Application for Licence Amendment

Licence Number	L8676/2012/1
Licence Holder	AngloGold Ashanti Australia Limited
ACN	008 737 424
Application Numbers	APP-0029297; APP-0029793
Premises	Tropicana Gold Mine Legal description – Part of Mining Tenement M39/1096 As defined by the coordinates in Schedule 2 of the Revised Licence
Date of Report	20 October 2025
Decision	Revised licence granted

Figure 2: Paste plant hardstand location

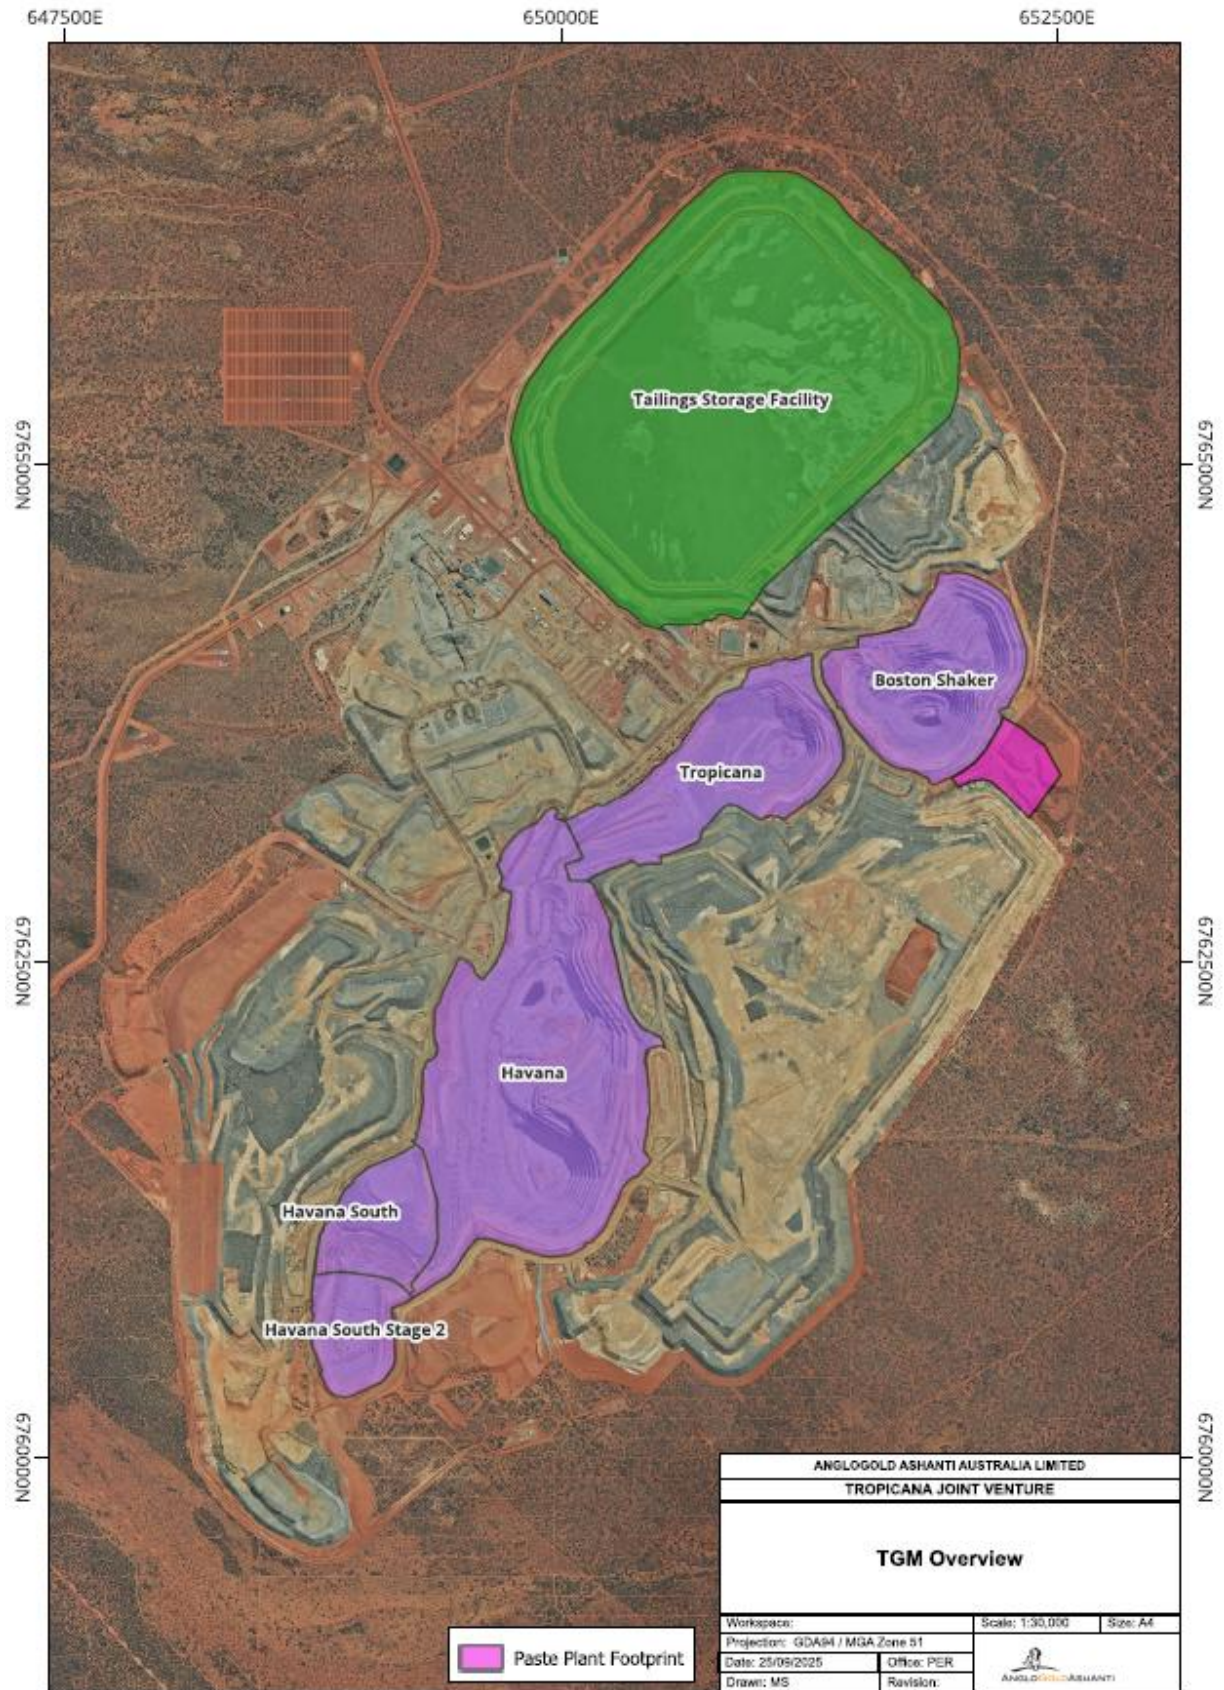
Section 2.2.3	This section refers to the incorrect Licence L8676/1988/14. AGAA requests that the Licence number is amended to reflect the Sunrise Dam Gold Mine Licence number L8676/2012/1.	Requested change has been accepted
Figure 2	AGAA has updated Figure 10 from the draft Licence Amendment to provide a slightly larger footprint area within which to construct the paste plant and tailings stockpile area. The original Figure was provided in Licence Amendment application to provide an indicative paste plant location only. AGAA requests that Figure 2 in the draft Licence Amendment Report be updated to reflect the new Figure provided by AGAA. Please refer to the attached 'Revised Figure 10 – Location of Paste Plant hardstand'.	Requested change has been accepted
Table 2 – Dust	AGAA requests that the proposed control in relation to tailings moisture content is amended to state: "Tailings are expected to have a moisture context of approximately 15%."	Requested change has been accepted
